SUNDRY NOTICES AND REPORTS ON WELLS		5. LEASE DESIGNATION AND SERIAL NO.
Do not use this form for proposals to drill or to deepen or reentry to a different reservoir. Use "APPLICATION FOR PERMIT-" for such proposals		Ute 4-20-604-62
SUBMIT IN TRIPLICATE		6. IF INDIAN, ALLOTTEE OR TRIBE NAME Ute Mountain Ute Indian Tribe

2. NAME OF OPERATOR CROSS TIMBERS OPERATING COMPANY.		8. WELL NAME AND NO. Ute Indians A #26
3. ADDRESS AND TELEPHONE NO. 2700 Farmington Ave., Suite 1, Bldg. K, Farmington, NM 87401 (505) 324-1090		9. API WELL NO. 30-045-29868

**Ute Indians A #26
SE/4 Section 2 T31N R14W
Proposal to Amend Drilling Plan**

Cross Timbers Oil Company
UTE DOME FIELD San Juan County, New Mexico
STRUCTURE: Top of Dakota
November, 1998 GKB/MSV

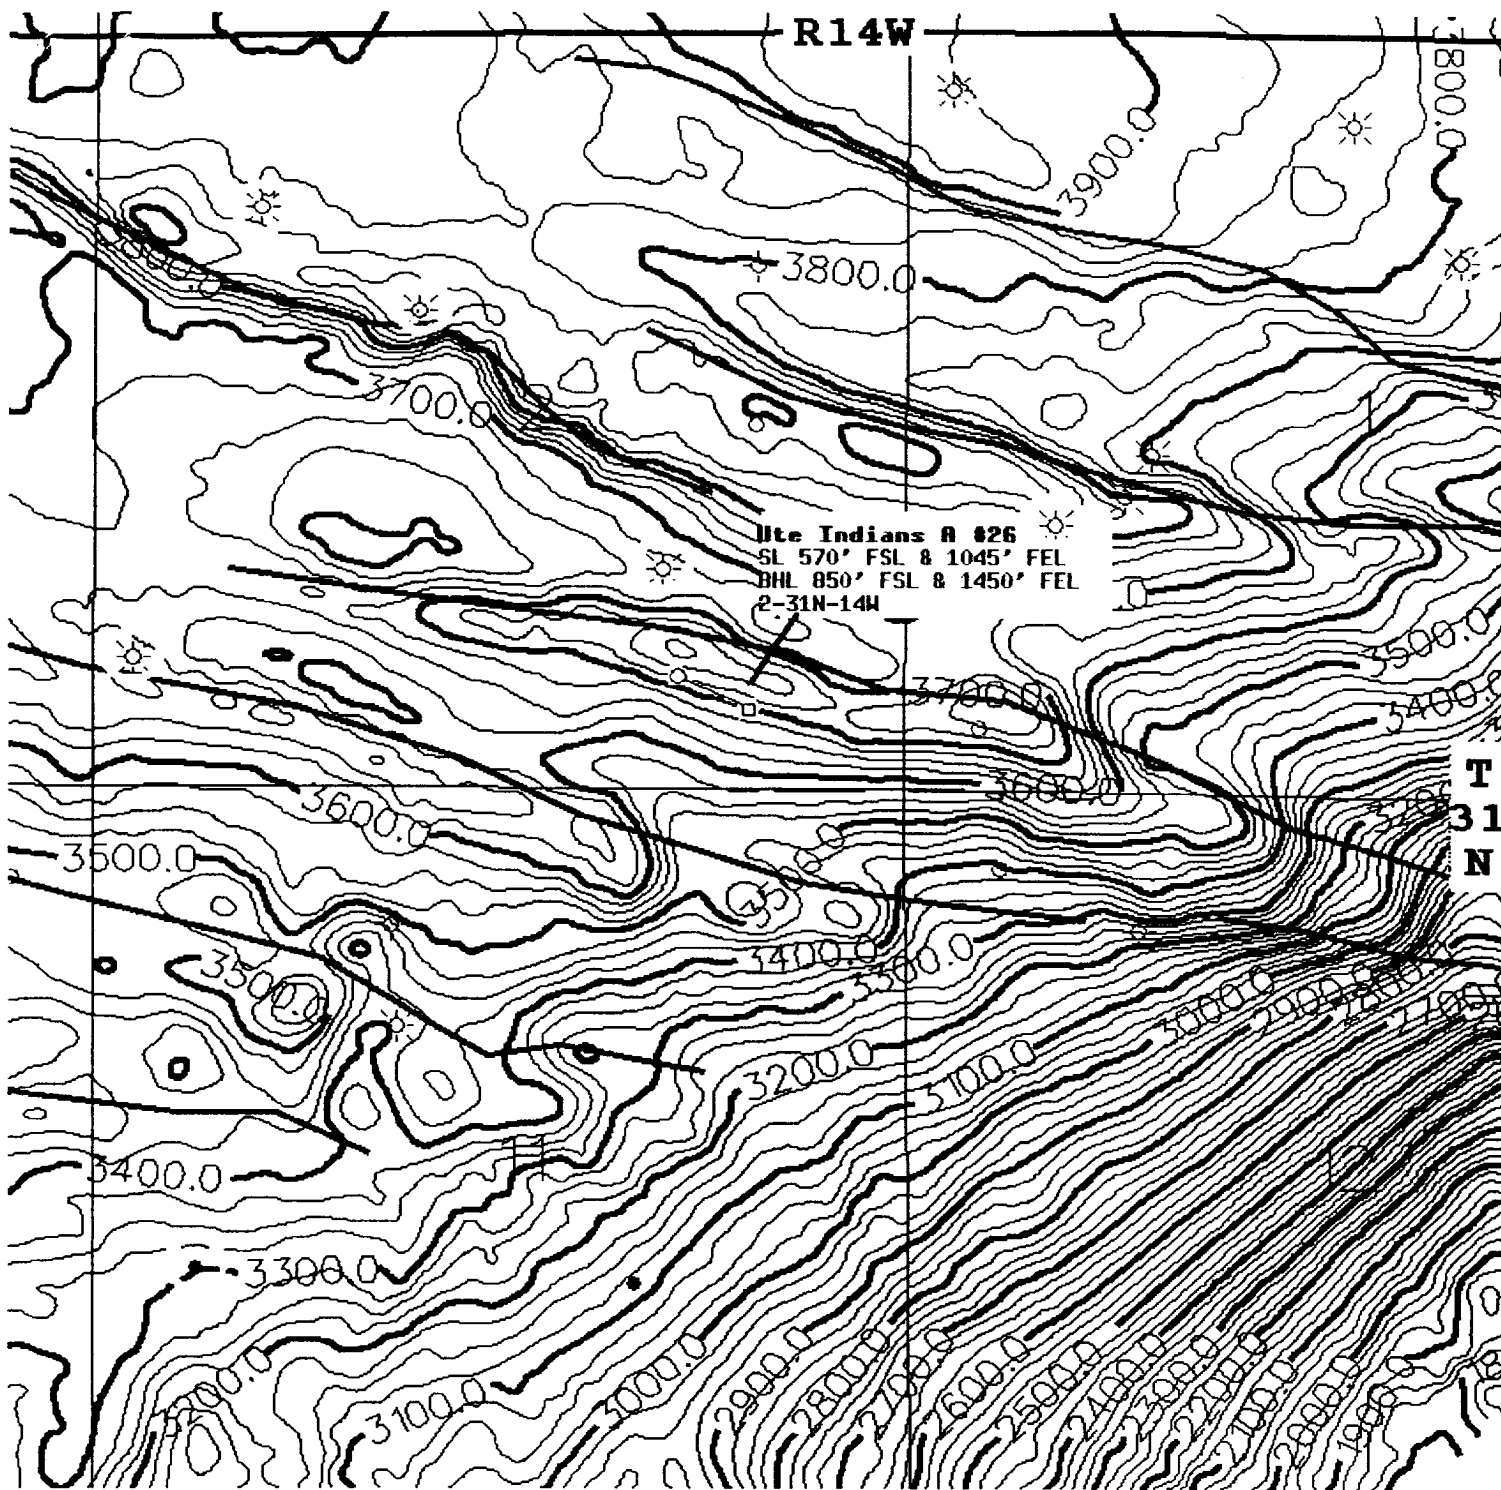
Based on the original APD on the Ute Indians A #26, this well was to be drilled as a directional well from a surface location of 570' FSL & 1045' FEL to a bottomhole location of 850' FSL & 1450' FEL. The original intent of this well was to drill directionally to the top of the Dakota formation and vertically from that point through the Paradox formation. This plan would enable the evaluation of the lower Dakota and Morrison formations at a structurally high position in an untested fault block (see attached map). This well was also intended to recover reserves that were unrecoverable in the Paradox by the Ute Indians A #7.

Cross Timbers Oil Company is requesting the option to drill this well as a directional well or a vertical well. Currently, the Ute Mountain Tribal J #6 located in the SW/4 Section 1 T31N R14W is to be the first well drilled at Ute Dome in 1999. This well is a Dakota and Morrison test intended to test the same fault block as the Ute Indians A #26. Based on the information gathered on the Ute Mountain Tribal J #6, it may be preferable to drill the Ute Indians A #26 as a vertical well at the previously approved surface location. If the fault block needs further evaluation at a structurally high point in the Dakota and Morrison, the Ute Indians A #26 would be drilled as a directional well. If the need for further evaluation at a structurally high position is not warranted, the well would be drilled as a vertical well to the Paradox. A vertical well would enable the evaluation of the Dakota and Morrison formations at a structurally lower position on the fault block and alleviate the drilling and operational issues associated with a directional well.
